**Sur-Rebuttal Analysis  
of the Applicant's  
Experts' Rebuttal Opinions**

By  
Dr. Willem A. Schreüder & Dr. Devraj Sharma  
Principia Mathematica Inc.

June 19, 2000

Case No. 96CW014: Application for Water Rights by Park County Sportsmen’s Ranch, LLP

Figure SR-2e.

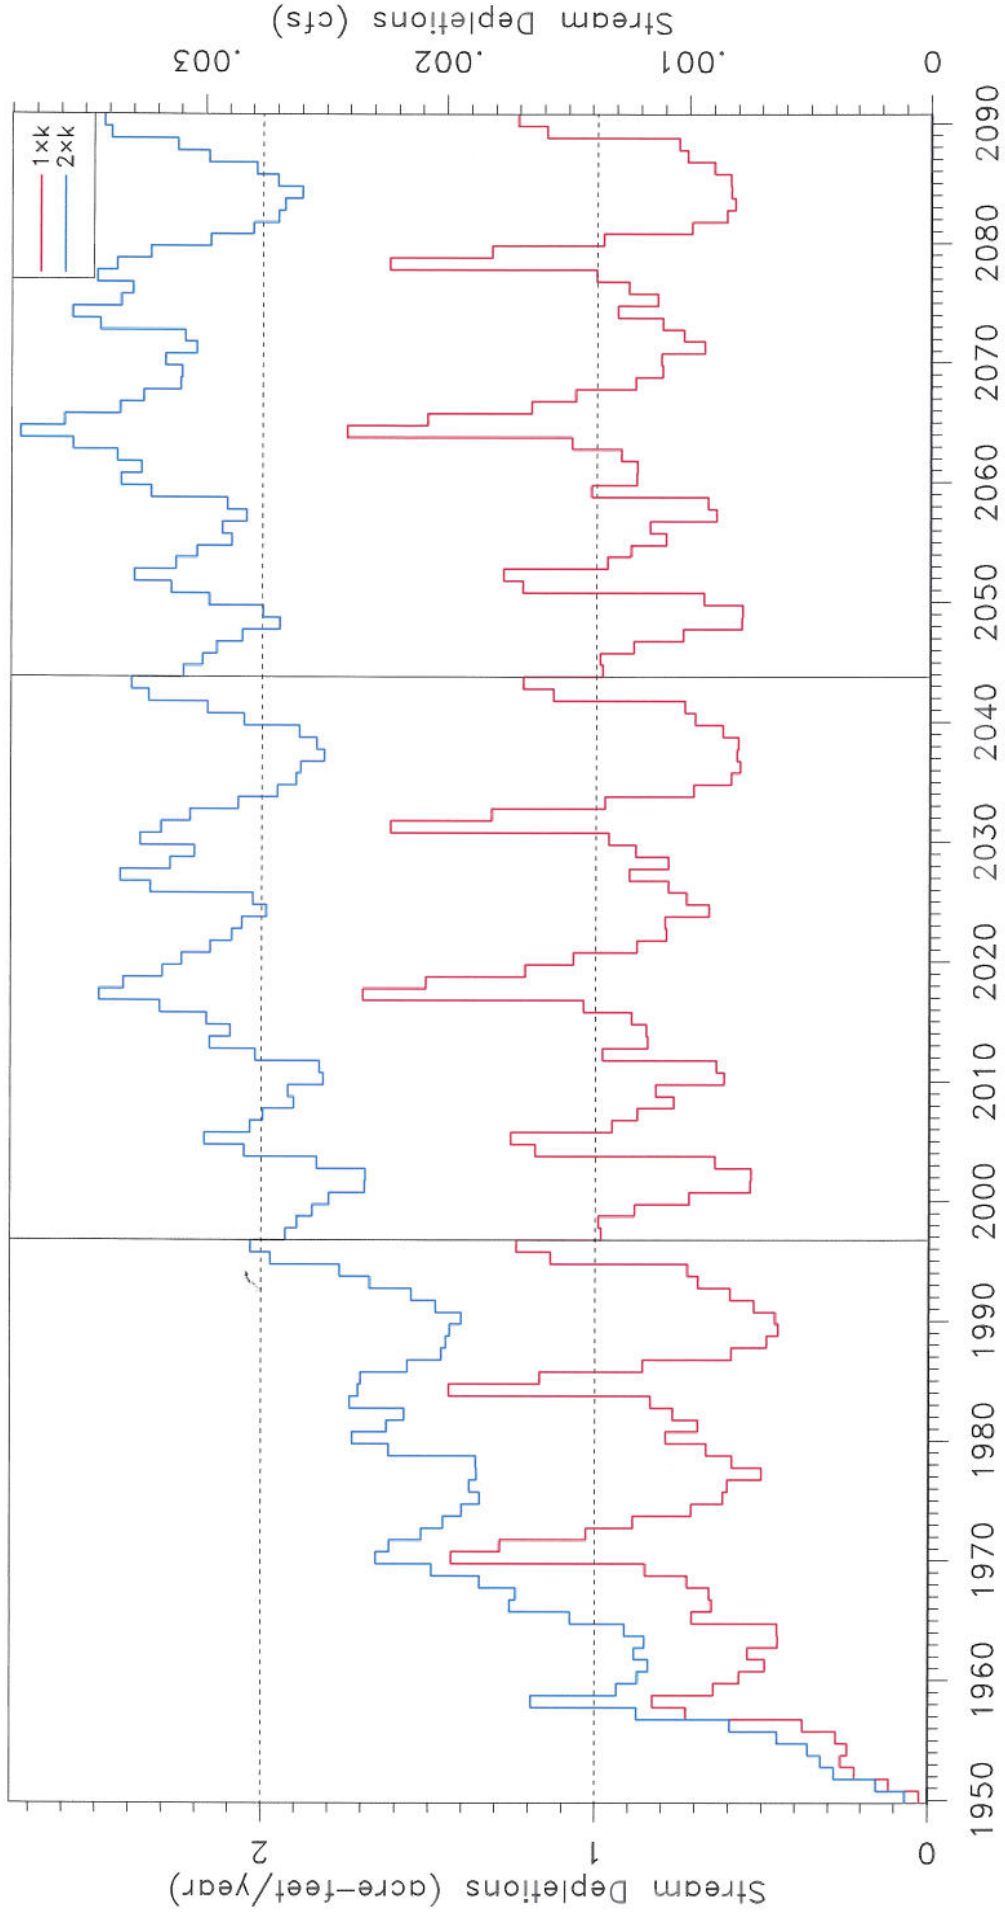
- (20) Notwithstanding the rebuttal opinions offered by the Applicant's experts [*see JWC, 2000b, Part-II, p47, p48, p49; van der Heijde Deposition, Vol-3; Eastman Deposition, Vol. 6*], the predictions of stream depletions made by the Applicant's ground water model remain fatally flawed. Principia's sur-rebuttal analysis has clearly demonstrated that the depletions to streams flowing through South Park, as predicted by the Applicant's model, are extremely sensitive to even minor variations in hydraulic conductivity of the aquifer materials through which they flow. Examples are presented in Figure SR-2a through Figure SR-2e of five different streams in which the increases and even decreases to predicted depletion caused by hydrogeologically small changes to the prescribed hydraulic conductivity values, can be clearly observed. Principia's sur-rebuttal analysis is corroborated by sensitivity analysis only recently conducted by RMC as reported in their June 6, 2000 memorandum.

Figure SR-3b.

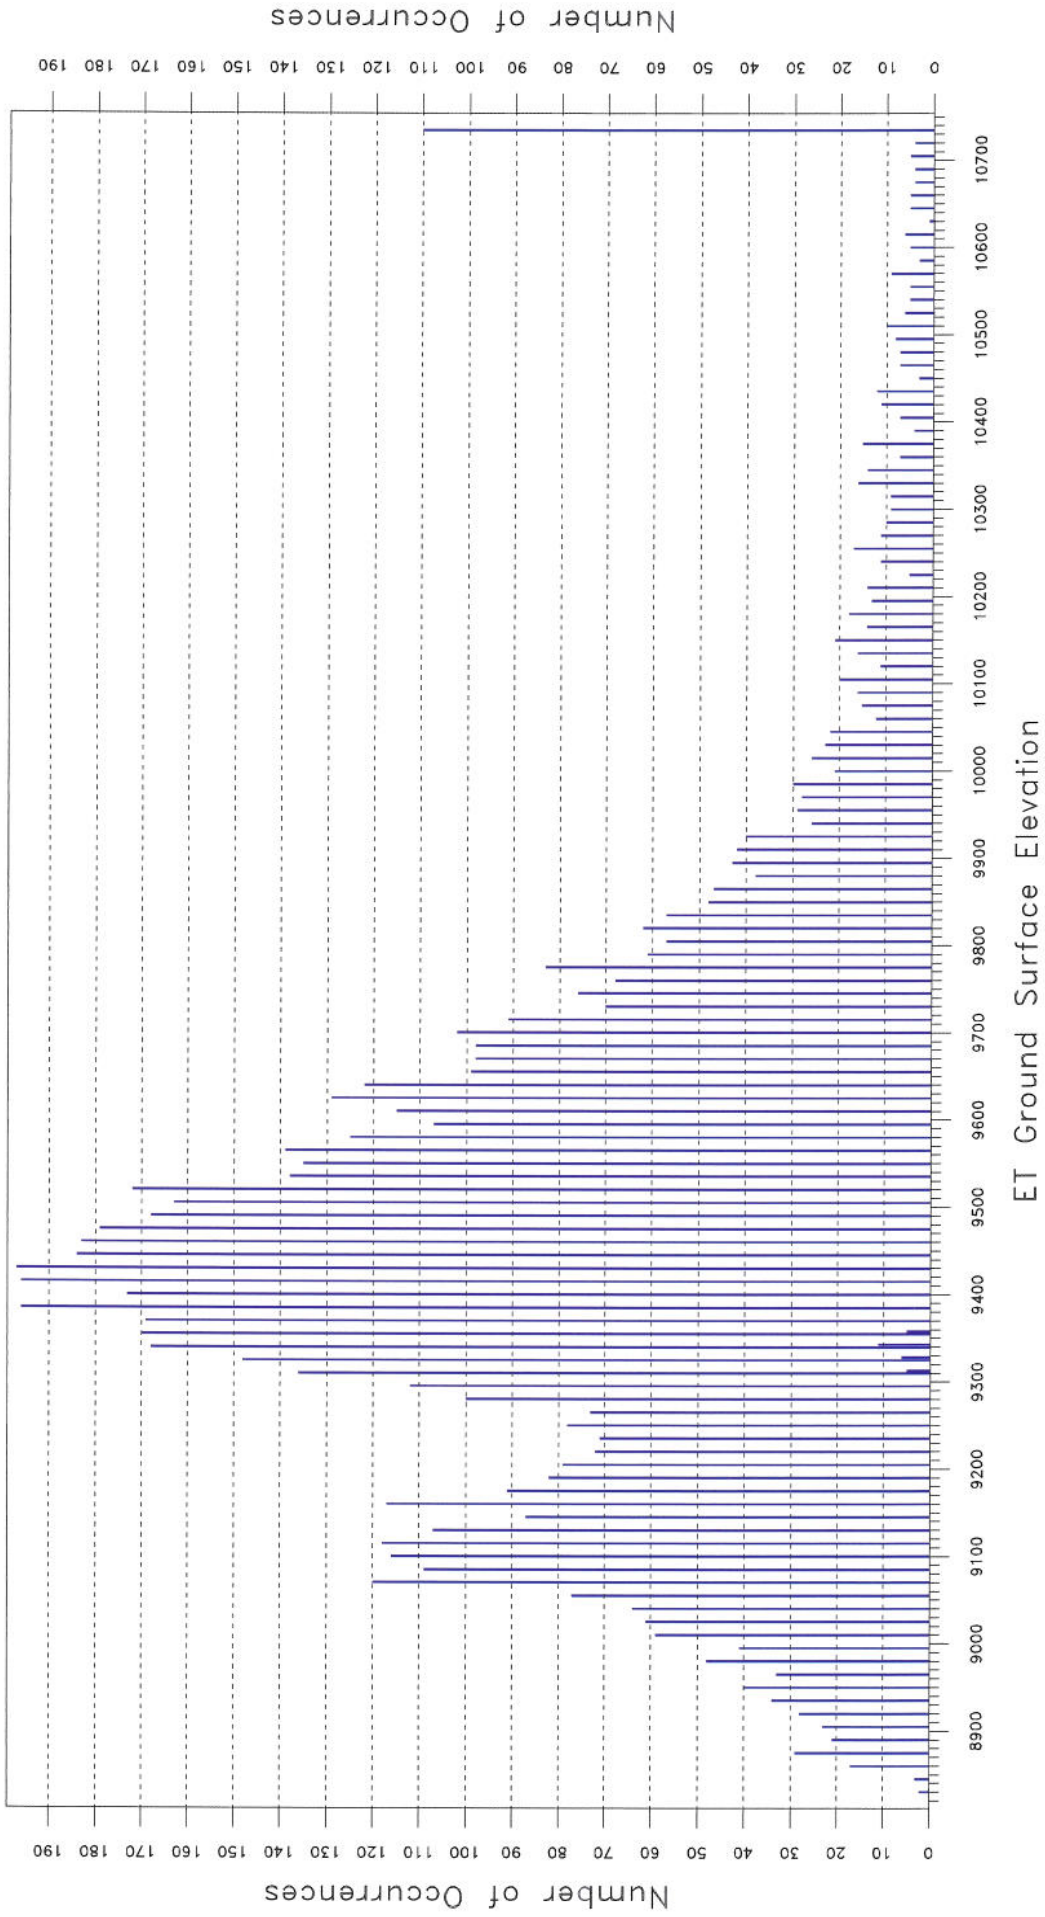
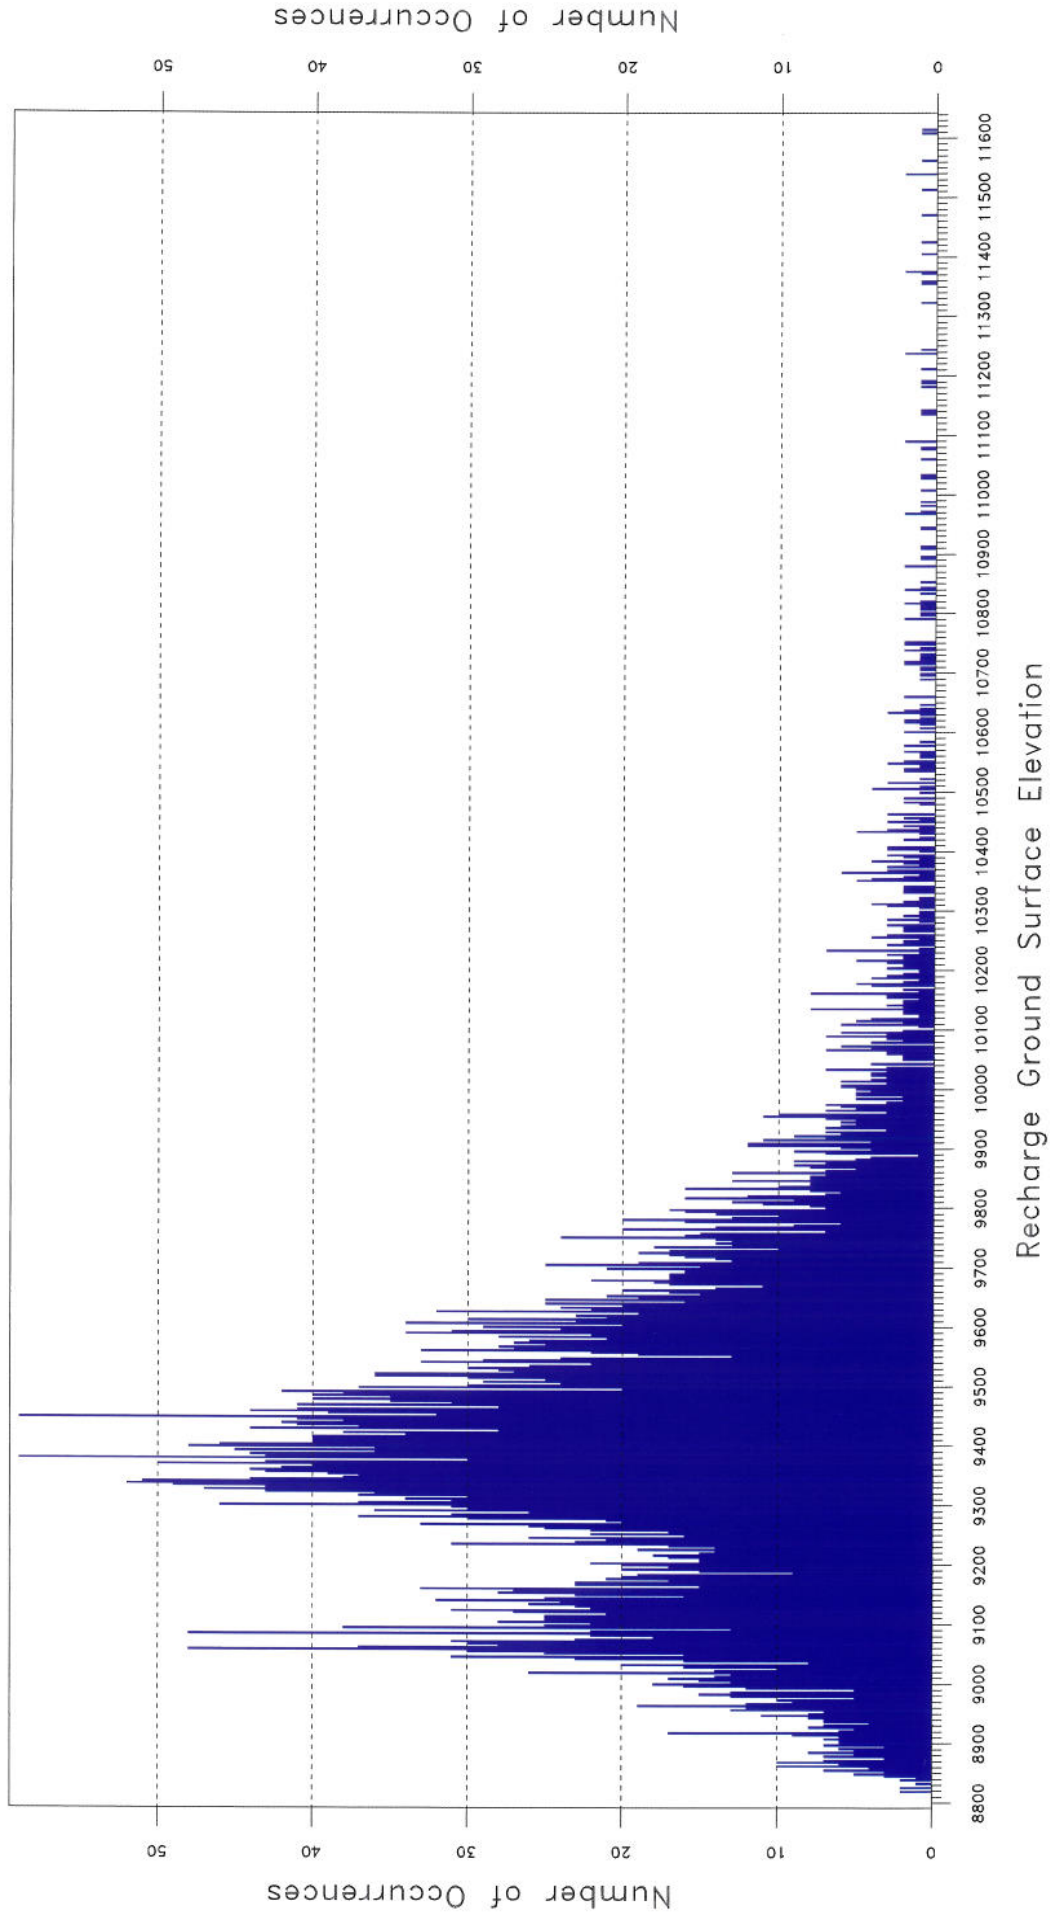
- (21) Notwithstanding the rebuttal opinions offered by the Applicant's experts [*see JWC, 2000b, Part-II, p50, p51*], the representations of vegetative consumptive use in, and predictions of evapotranspiration (ET) salvage by, the Applicant's ground water model are fatally flawed. Since this model remains as the only tool that Applicant retains to estimate ET salvage in this matter, it is important to evaluate these flaws. Sur-rebuttal analysis conducted by Principia clearly demonstrate that, even when based upon the flawed representation of vegetation consumptive use in the Applicant's ground water model, the quantities of ground water claimed to be salvaged in South Park are extremely sensitive to the prescribed values of hydraulic conductivity. Figure SR-3a clearly demonstrates this sensitivity of its predictions to even minor changes in the unmeasured but prescribed values of hydraulic conductivity in the model. Principia's analysis in this respect does not imply any endorsement of these values. Furthermore, that the unsubstantiated rebuttal opinion offered by the Applicant's modelling expert [*see JWC, 2000b, Part-II, p51*] that the prescriptions of ground surface elevation in the context of ET and recharge representations are not incorrect is demonstrably false is depicted in Figures SR-3b and SR-3c and in the hydrographs contained in Principia's previous supplementary report.
